Memo

To	Neil Dixon	Company	Mardie Minerals Pty Ltd
From	Bruce Harvey & Duncan Storey	Job No.	293C
Date	4/11/2020	Doc No.	009b
Subject	Mardie Project – Desktop Groundwater Risk Assessment

Figure 2 – Conceptual Geological Profile – Mardie Pool Area

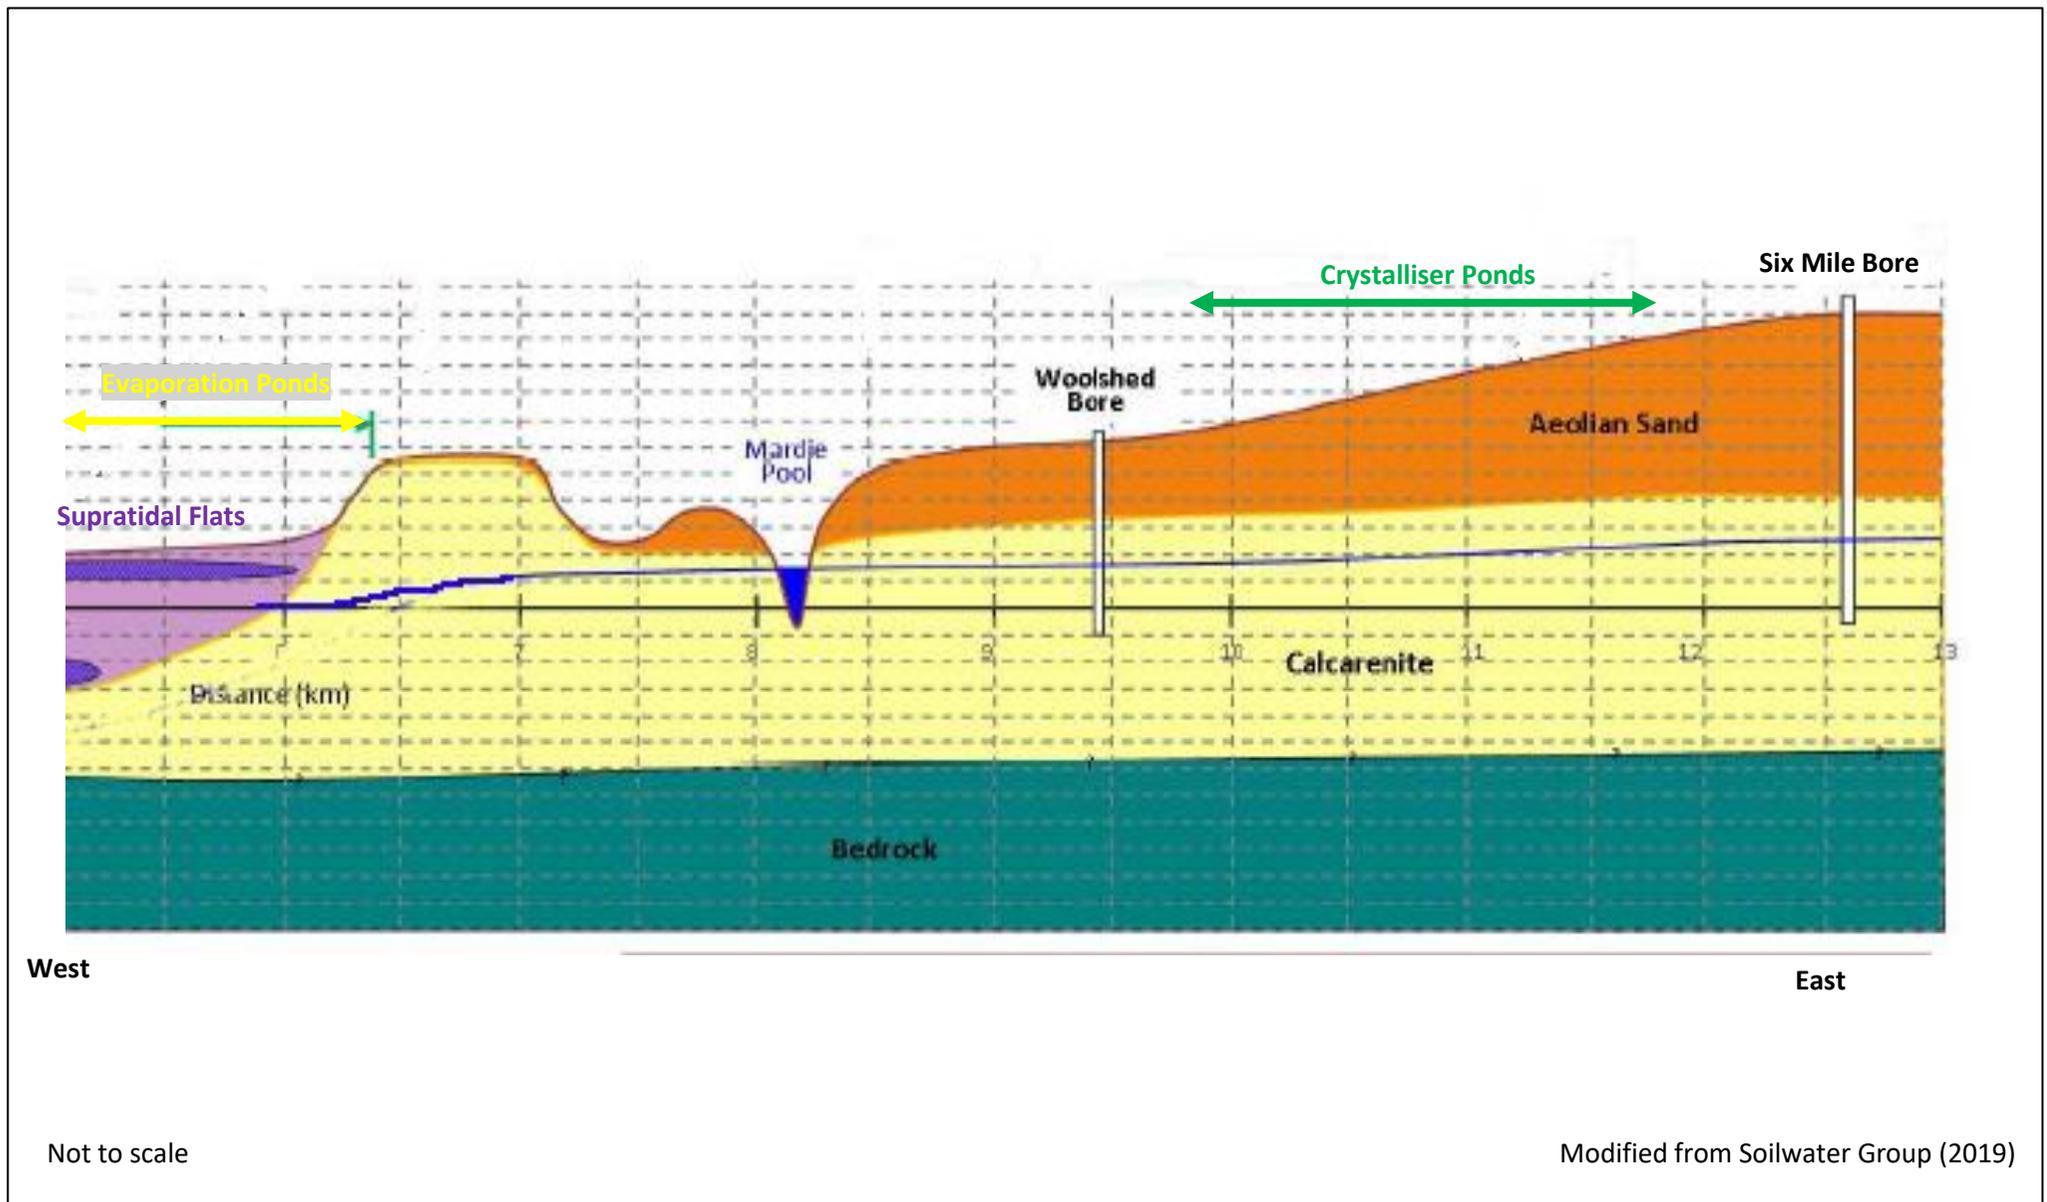
The geological model proposed by Soilwater Group (2019) postulates that the project area is generally underlain by a moderately to highly calcreted shelly calcarenite layer (Figure 2). According to this model, on the eastern side of the Supratidal Flats the calcarenite is unconformably overlain

Soilwater Group (2019) proposes the calcarenite unit dipping below the sediments of the supratidal flats to the west, with interfingering alluvial layers overlying. CMW proposes that Units 4a and 5 are continuous and sub-horizontal beneath the evaporation ponds and further to the west. The CMW model is the favoured option for analysis of groundwater flow from beneath evaporation ponds towards the tidal creeks and this has not been used in the Soil Water Group modelling to date.

Figure 3 – Representative Geological Cross Section Beneath Evaporation Ponds (after CMW 2020)

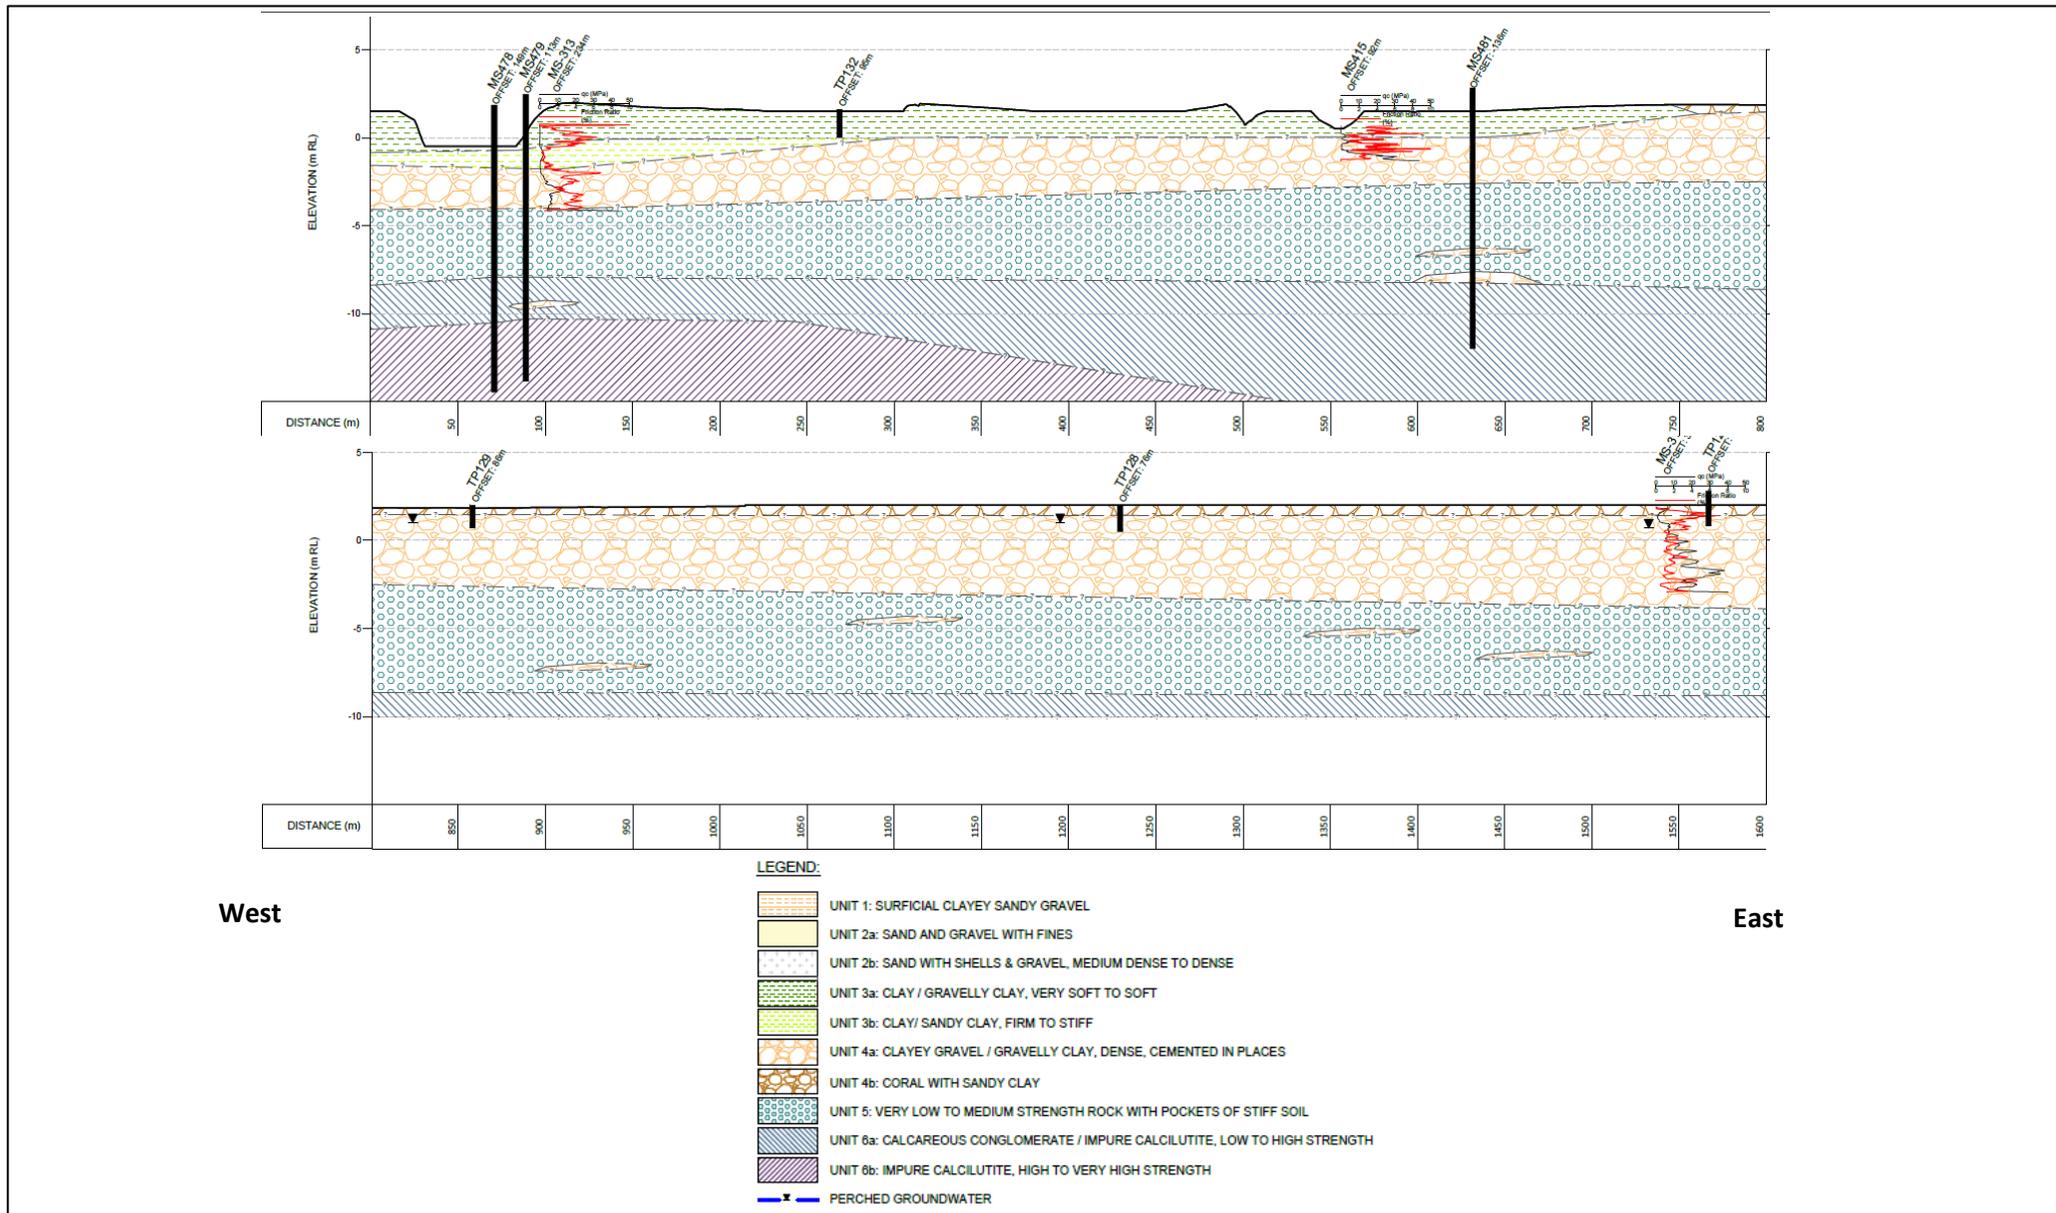
Interpreted distribution of these geological units across the site is described by cross sections in CMW(2020). Figure 3 provides a representative geological cross section beneath evaporation ponds (after CMW 2020). The section indicates clayey gravel/gravelly clay (Unit 4) extending to approximately 6m below ground level. Inland, sandy clay is evident at surface.

AQ2 analysis of available water level data indicates that the SWL is likely to be within 1m of the surface, in the gravelly clay layer (Unit 4 of Figure 3). Moreover, the evidence for hydraulic separation (from the underlying calcarenite) nor a perched water table are not clear. If this is the case then saline seepage will reach the water table much faster than modelled, and potential for mounding may be greater than stated. Moreover, the distribution of hydraulic head that will influence both the actual and modelled seepage response will be fundamentally different to that modelled to date. In particular, if there is hydraulic connection throughout the aquifer, then the propagation of pressure from the pond, through the calcarenite aquifer, may result in changes to the position of the saline interface and potential changes to freshwater “upwelling” that will be occurring over the saline water.

Figure 5
**Mardie Project
 Groundwater Levels
 and Flow Direction**

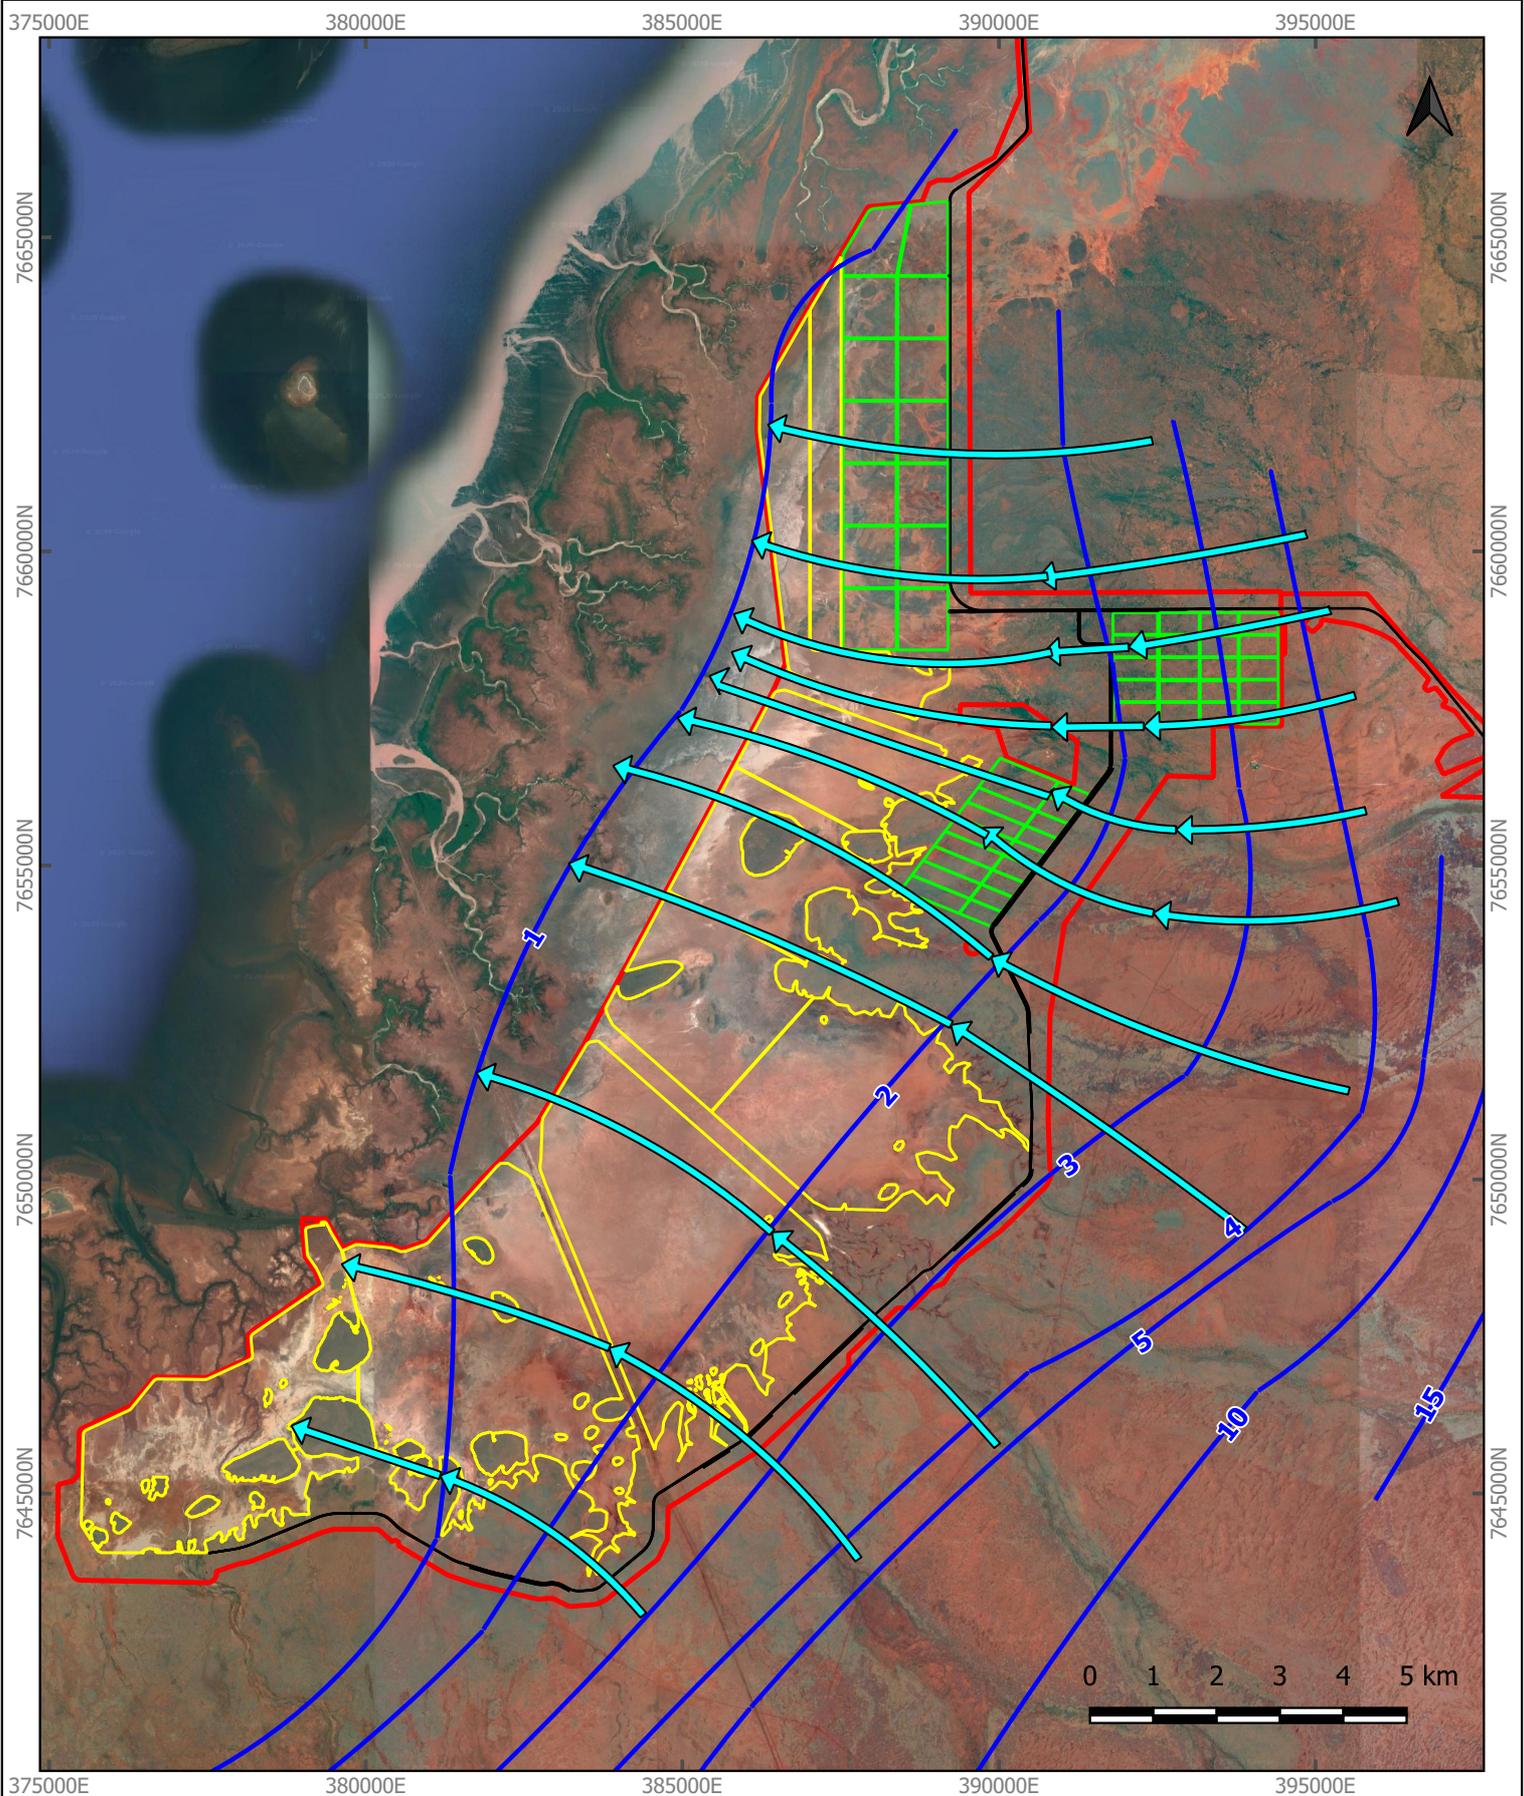
Although taken at a range of dates, these combined water level datasets present a generalised view of water depth across the project area. Elevation data supplied by BCI Minerals was used to generate relative water level and flow gradients. Figure 4 displays simplified groundwater level contours and flow direction for the area surrounding Mardie Pool. Figure 5 provides estimated groundwater level across the entire site.

Figure 5 indicates that groundwater flow is generally towards and perpendicular to the coastline. Flow gradient is relatively steep beneath the elevated land to the west of the project. The gradient reduces significantly on the flats beneath the proposed evaporation ponds to approximately 2m in 8km, or 0.00025. Groundwater flow passing beneath evaporation ponds

Figure 6 – Surface Elevation and Water Level – Mardie Pool Area

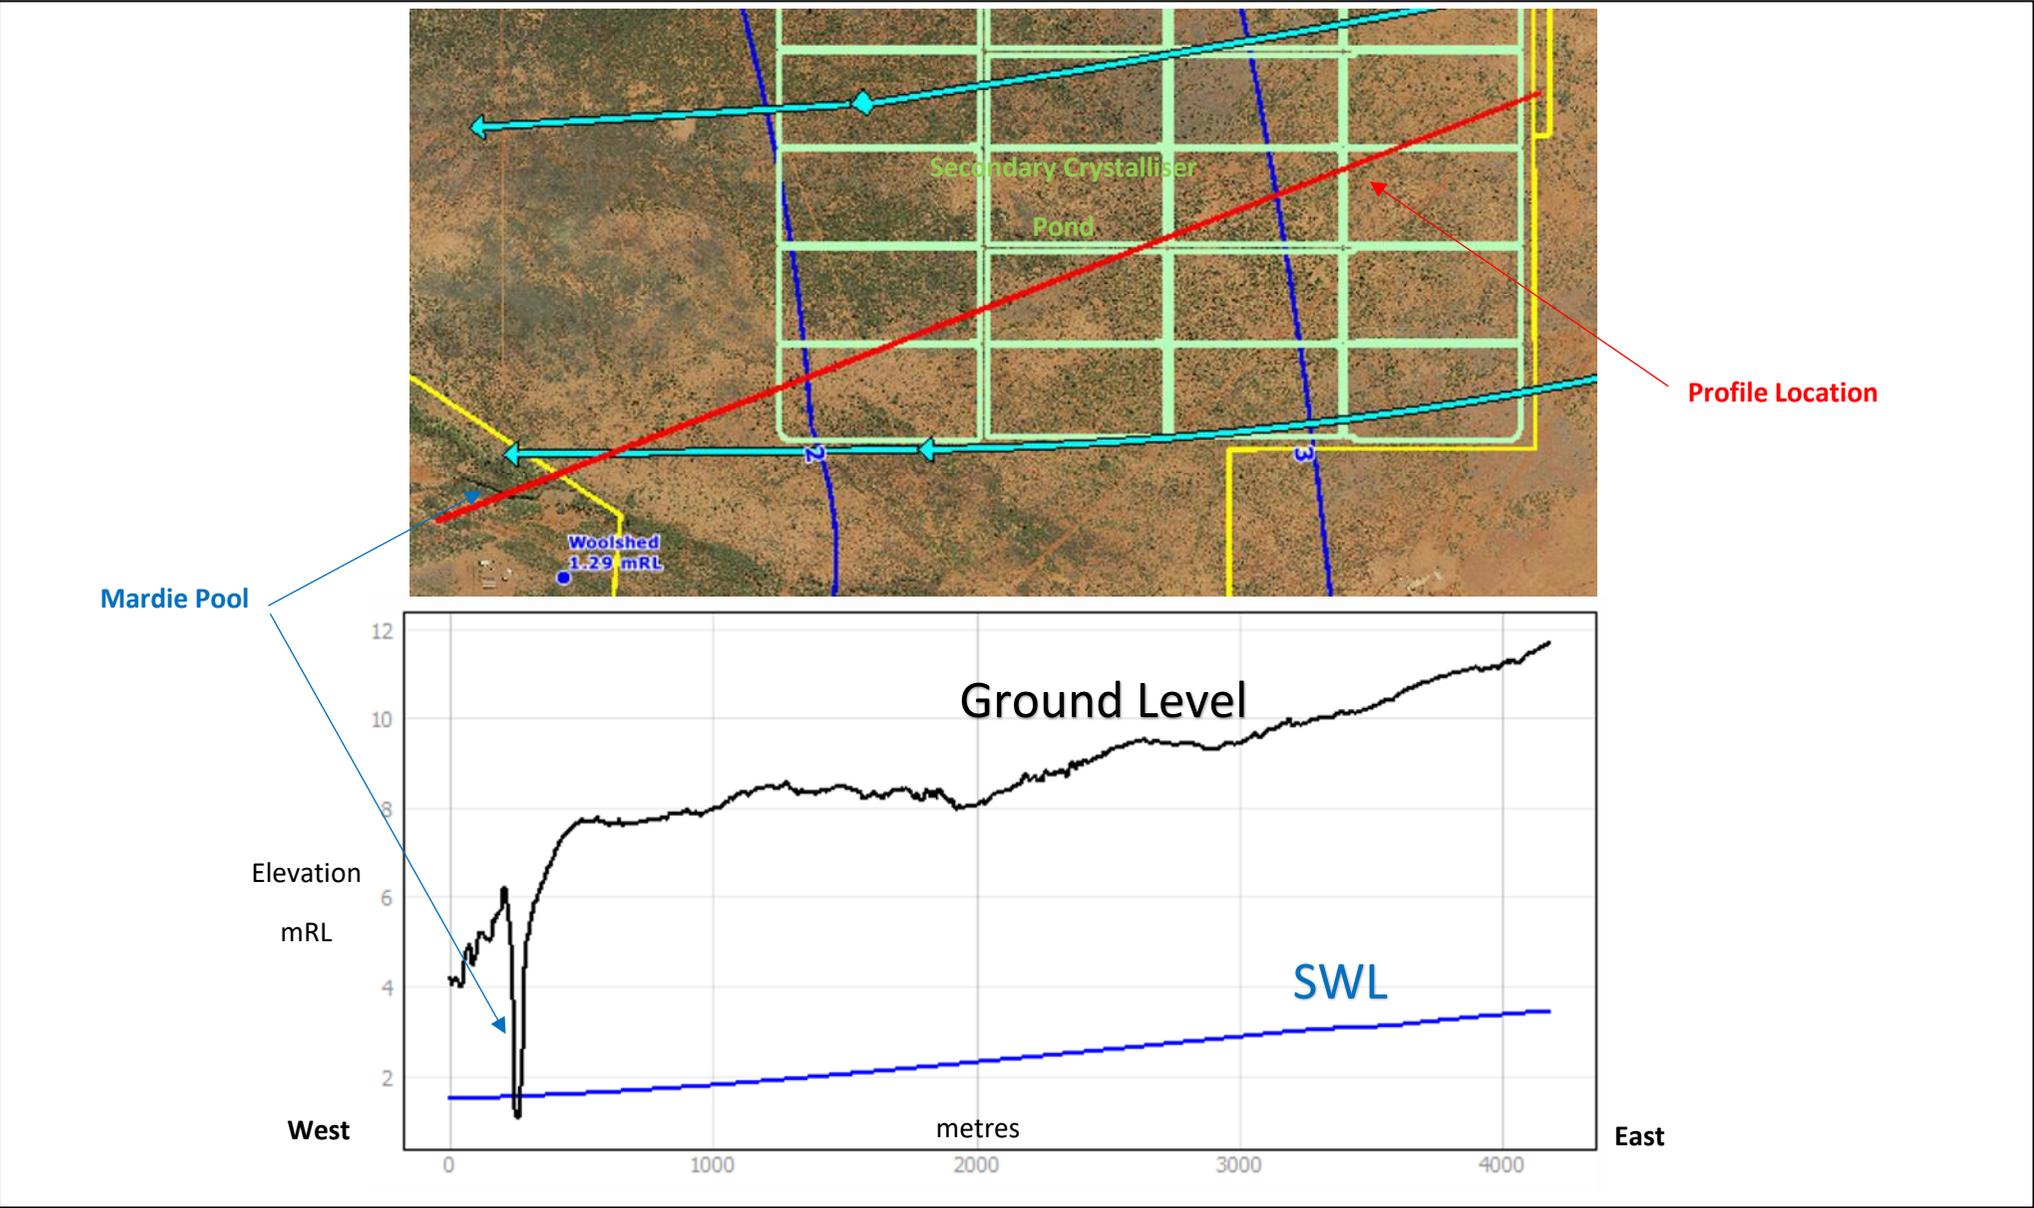
Figure 6 indicates that groundwater flow from beneath the footprint of the secondary crystalliser is likely to intercept Mardie Pool, and that this groundwater may be sourced from below the closest corner of the secondary crystalliser pond (a distance of approximately 1000m).

Figure 6 presents profiles across the secondary crystalliser ponds and Mardie Pool, displaying ground surface and SWL interpolated from the available bores and CPT sites. The profile indicates the following:

- Mardie Pool is likely to be a permanent surface water feature due to connection to the groundwater system;
- Groundwater level is approximately 6m below ground surface at the secondary crystalliser pond, increasing gradually to the east; and
- Groundwater gradient near Mardie Pool is approximately 0.5m/km (or 0.0005), falling to the west.
